**SECTION 00 90 01  
BIDDING AND CONTRACT REQUIREMENTS  
ADDENDUM NUMBER (05)**

**Re: ADDENDUM NUMBER (05) TO THE BIDDING DOCUMENTS FOR**

**Bid 24-032 Elgin Sports Complex Expansion**

Architect's Project Number: 14106

DRAWING TITLE  
**LAYOUT AND MATERIALS PLAN - AREA B**

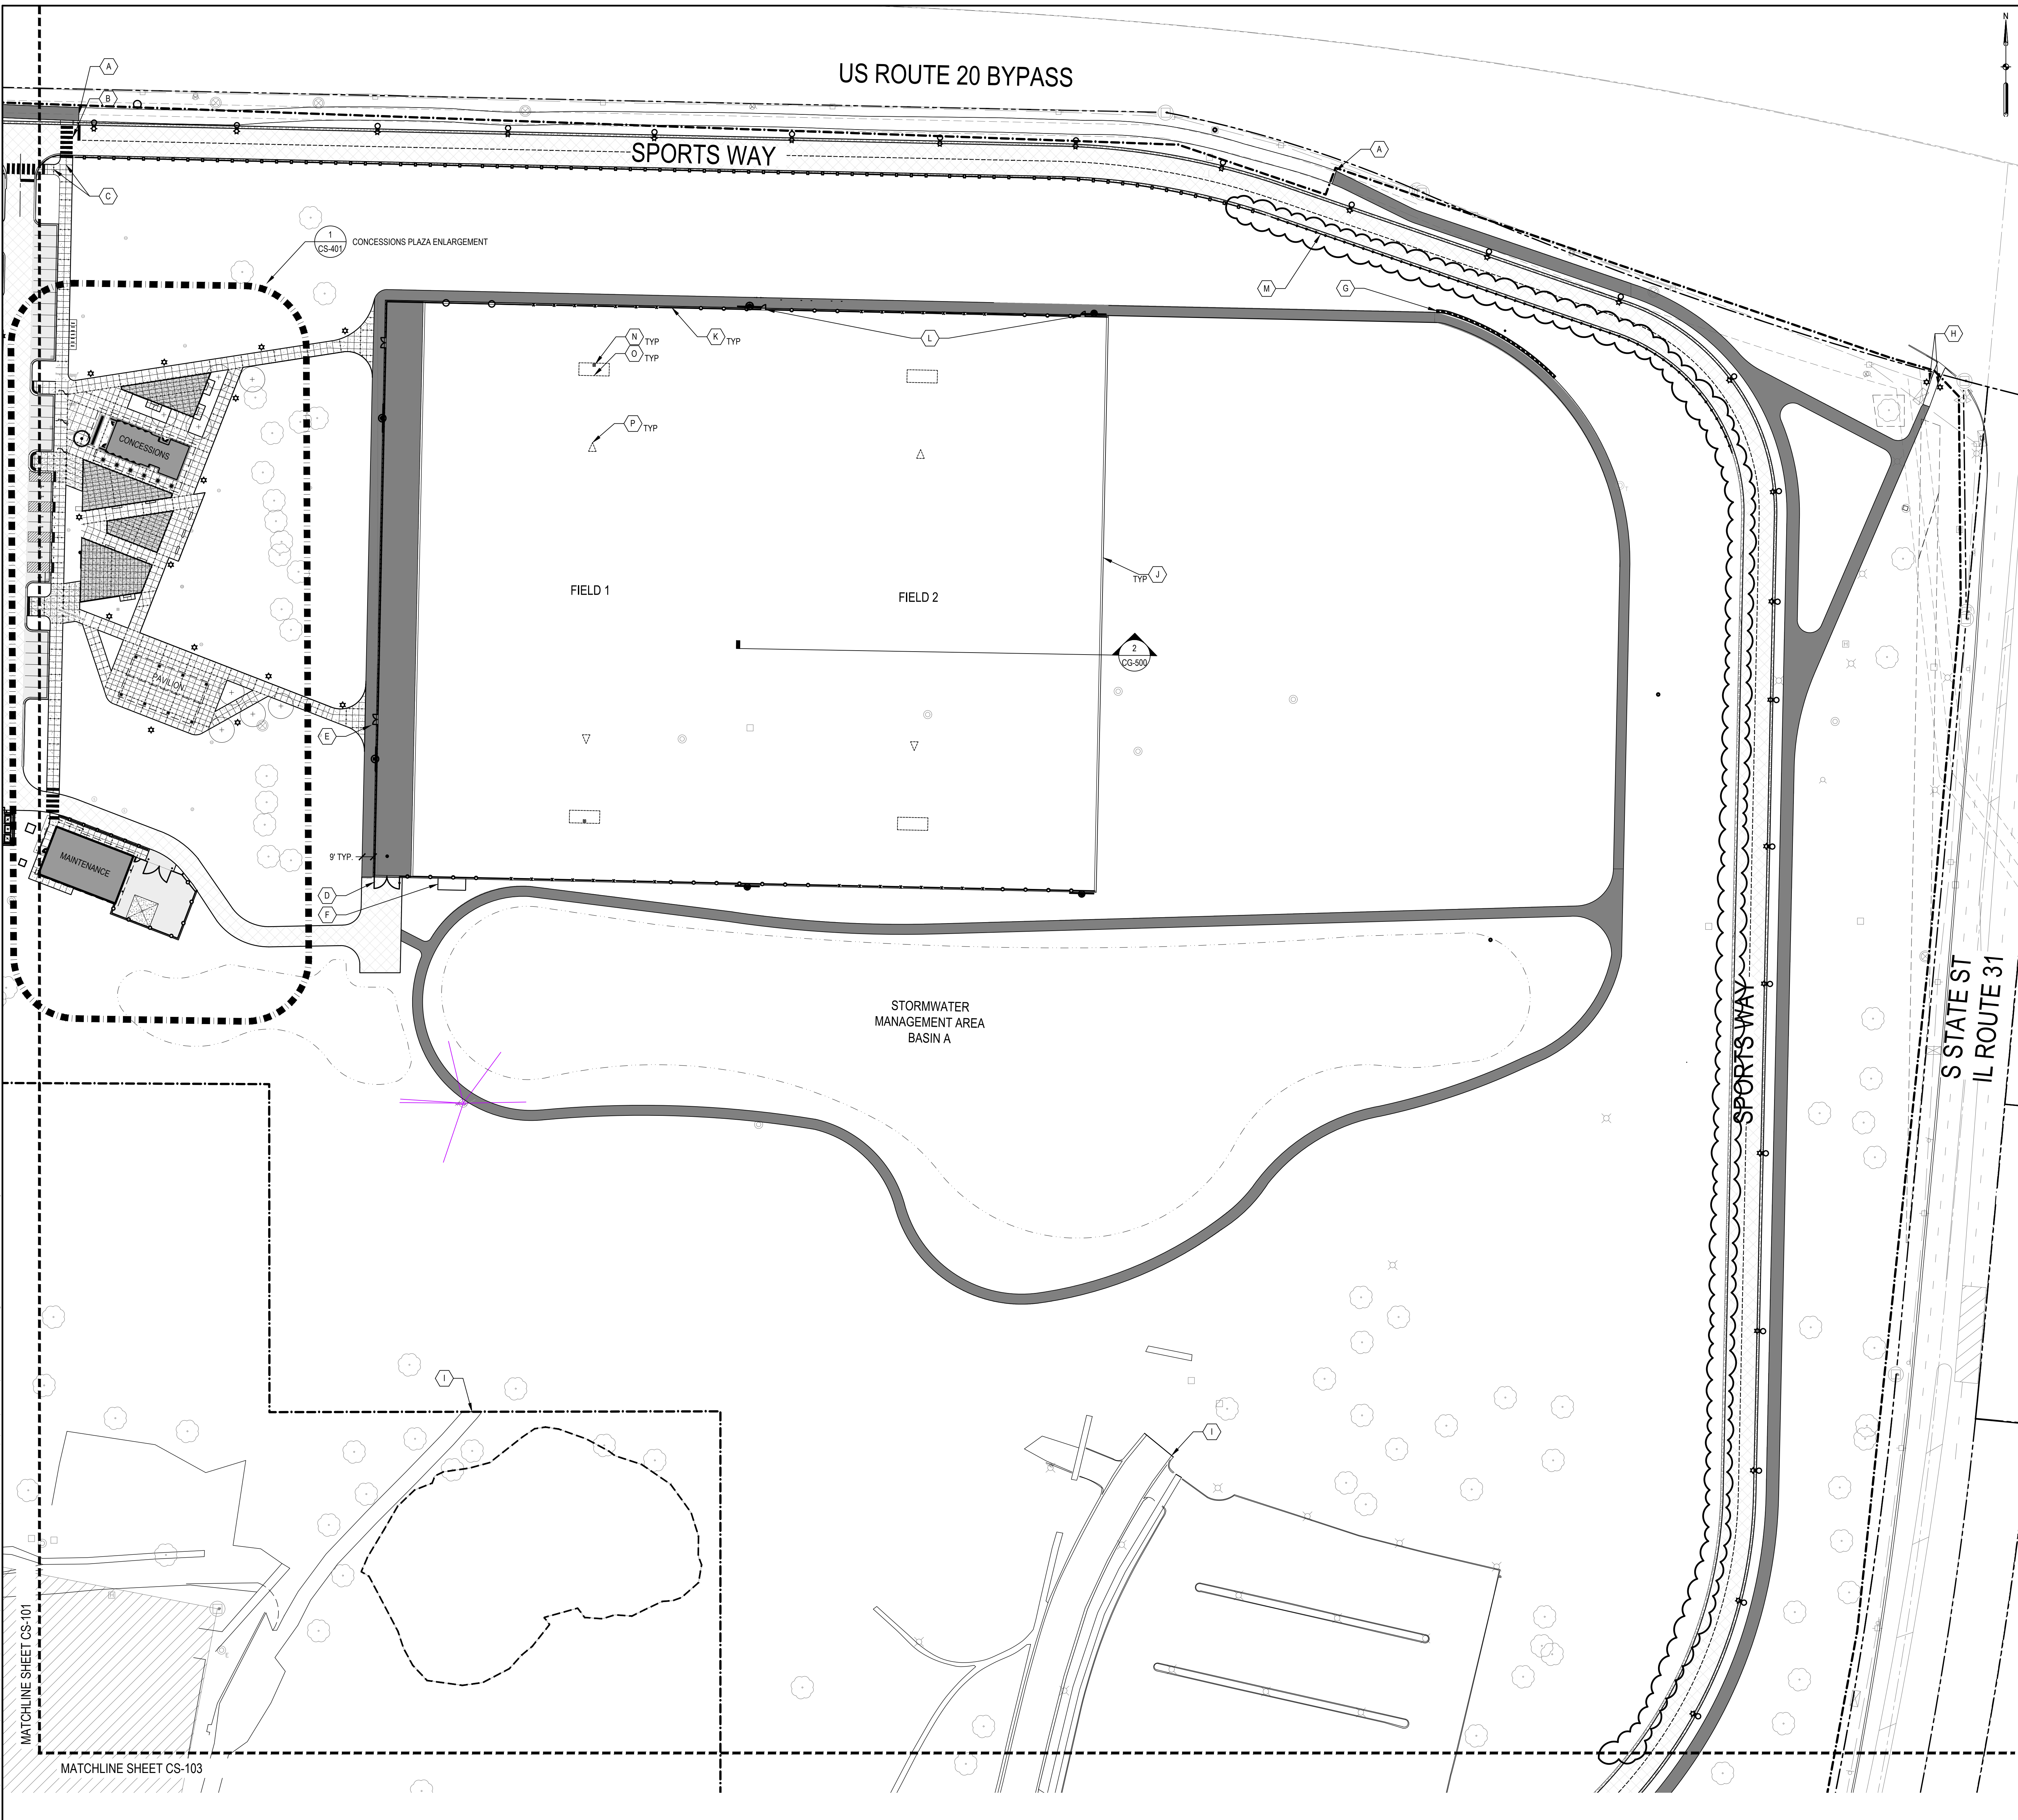
1. CS-101 - LAYOUT AND MATERIALS PLAN - AREA B & CS-102 - LAYOUT AND MATERIALS PLAN - AREA C - Added gravel shoulder to west side of Sports Way
2. CS-401 - PLAZA ENLARGEMENT - Added Bench keyed notes
3. LP-102 - LANDSCAPE PLAN - AREA B - Revised limits and quantities of lawn seed mix
4. LP-103 - LANDSCAPE PLAN - AREA C - Revised limits and quantities of detention basin and lawn seed mixes
5. LP-501- PLANTING DETAILS AND SCHEDULE: Updated planting schedule
6. ALT-500 – ALTERNATE DETAILS - Updated Detail 8
7. Updated - IR-100 - IRRIGATION PLAN
8. Updated ALT-200 - ALTERNATE 2 – ATHLETIC FIELD 3 IRRIGATION
9. Updated ALT-201 - ALTERNATE 8 - CORE AREA IRRIGATION
10. Updated - IR-200 – IRRIGATION DETAILS
11. Updated - IR-201 – IRRIGATION DETAILS

CS-401

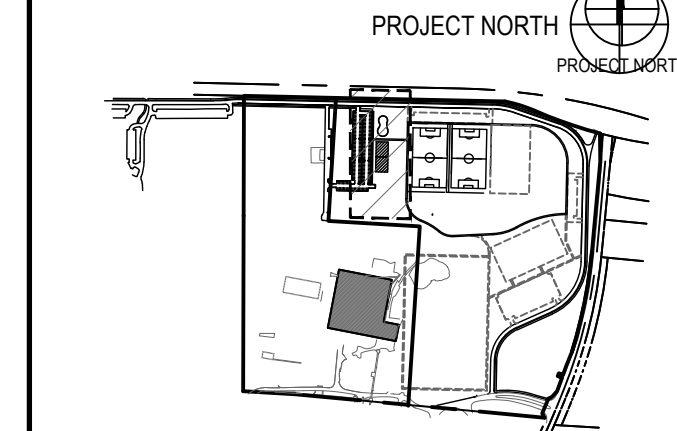
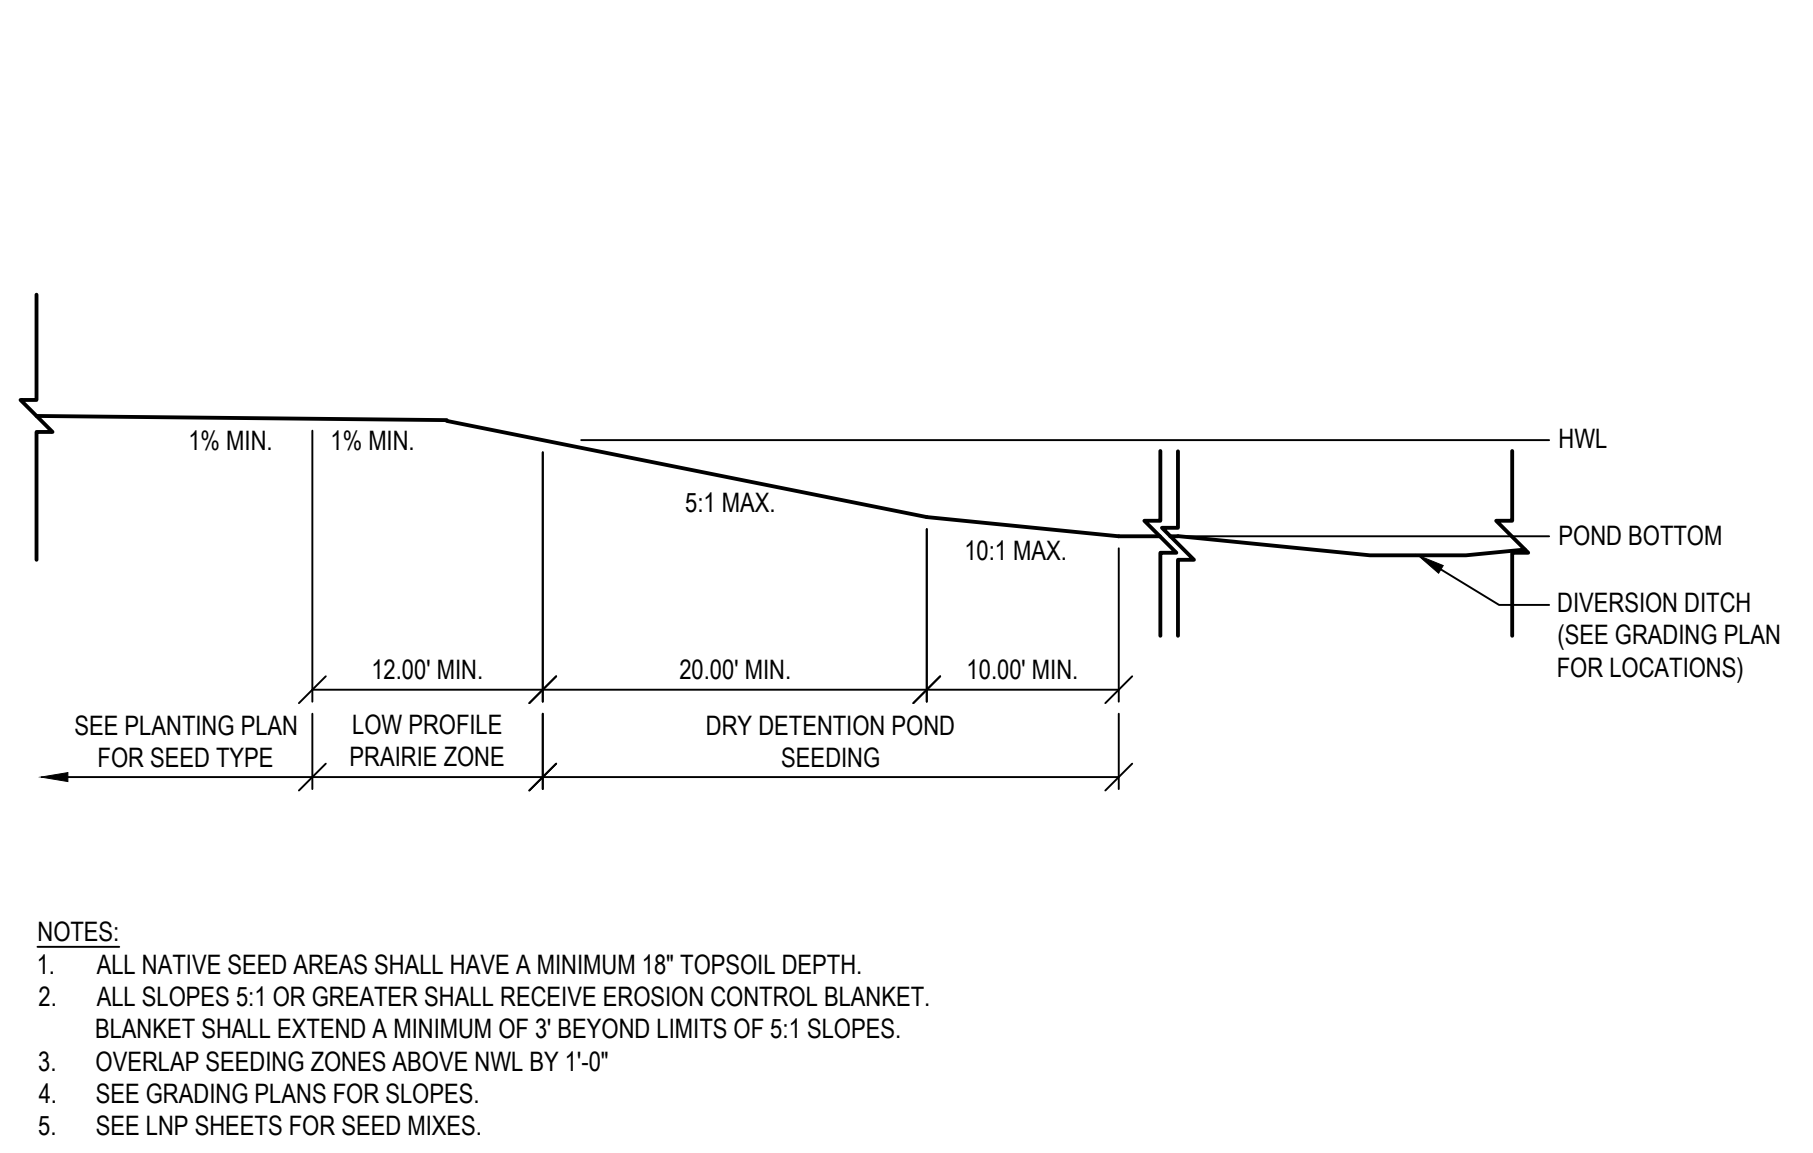
8. Wood Bench from Harvested tree from site: • Drawing CS-506 Detail 5 calls out for a wood bench to be made from a tree harvested from the site, what is the length. **See CS & ALT sheets. CS-401 reissued in Addendum 5 for bench location clarity in base bid. Coordinate work with G.H. Woodworking.**

9. • Drawing Alt-103 & Alt-500 show 4 Benches. Is this the only location we have Benches, are they only in Alternate 3? **See CS & ALT sheets. CS-401 reissued in Addendum 5 for bench location clarity in base bid. Coordinate work with G.H. Woodworking.**

TYPICAL DETAIL WOOD LEDGER SUPPORT OF JOISTS @ CMU OR CONCRETE WALL

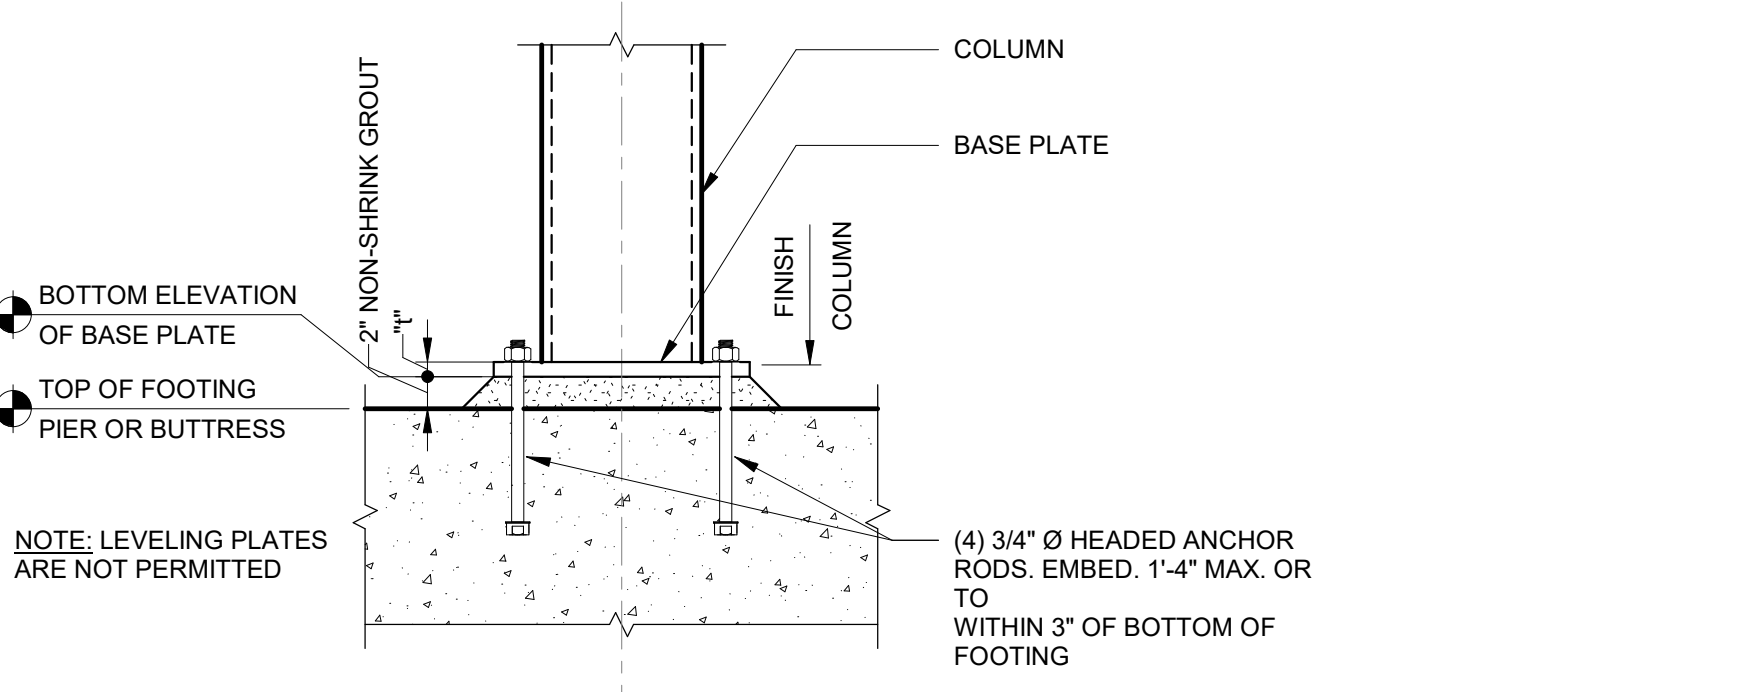
2. Refer 2/ S-111 Concessions Building Conditioned Envelope Roof Plan: **See following responses:**
3. Provide a detail showing the construction of the wood framing bearing condition at CL. AC, AF, AG-, and AJ. **Refer to "Typical Detail Wood Ledger Support of Joists @ CMU or Concrete Wall" on S-502**

4. Provide a detail showing the construction of the wood framing connection at the intersection of CL. A1 – AG-, CL. A1 – AJ, CL. A2 – AC, CL. A2 – AF, CL. A2+ - AF, CL. A2+ - AG-, CL. A4 – AC, CL. A4 – AF, CL. A5 – AG-, and CL. A5 – AJ. **Refer to "Typical Detail Wood Ledger Support of Joists @ CMU or Concrete Wall" on S-502**

10. 2. Provide a detail showing the construction of the wood framing connection at the intersection of CL. A2+ - AF, and CL. A2+ – AG-. **Refer to "Typical Detail Wood Ledger Support of Joists @ CMU or Concrete Wall" on S-502**

TYPICAL SAWN LUMBER JOISTS TO SAWN LUMBER GIRDERS

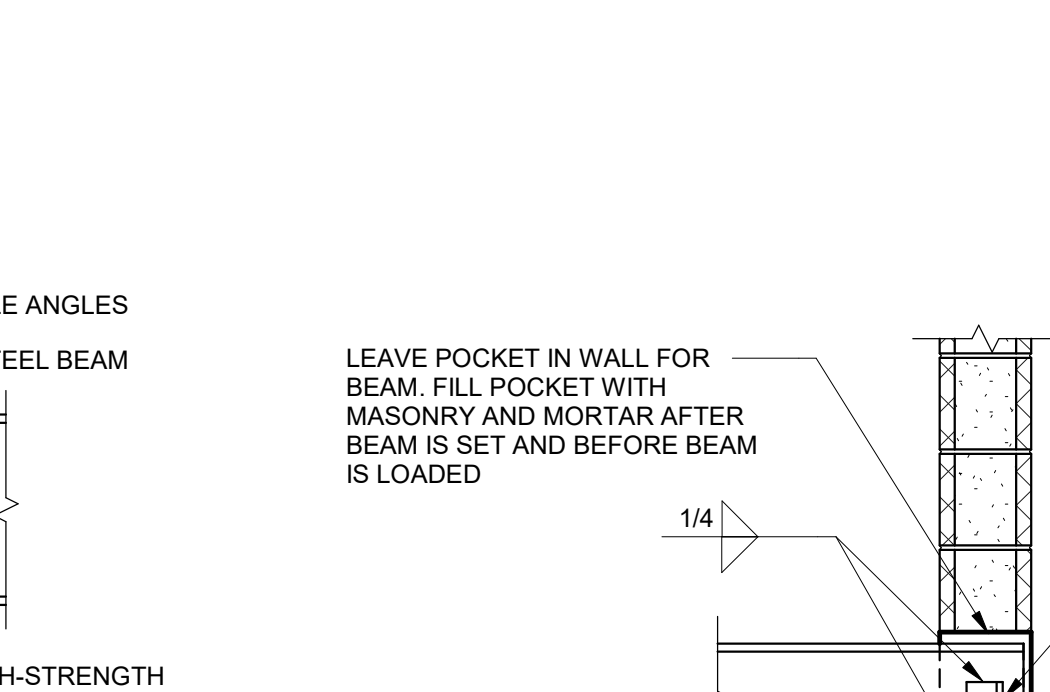
9. 1. Provide a detail showing the construction of the wood framing bearing condition at CL. AA, AB, AC, AF, AG-, and AJ. **Wood joists are not bearing along full CL. AA and AB and instead span to steel member W8x58, reference 1/ S-111. For CL. AC, refer to section detail 5/ S-401 for hold down angle connection. For CL. AF, refer to "Typical Sawn Lumber Joists to Sawn Lumber Girders" detail on S-502.**
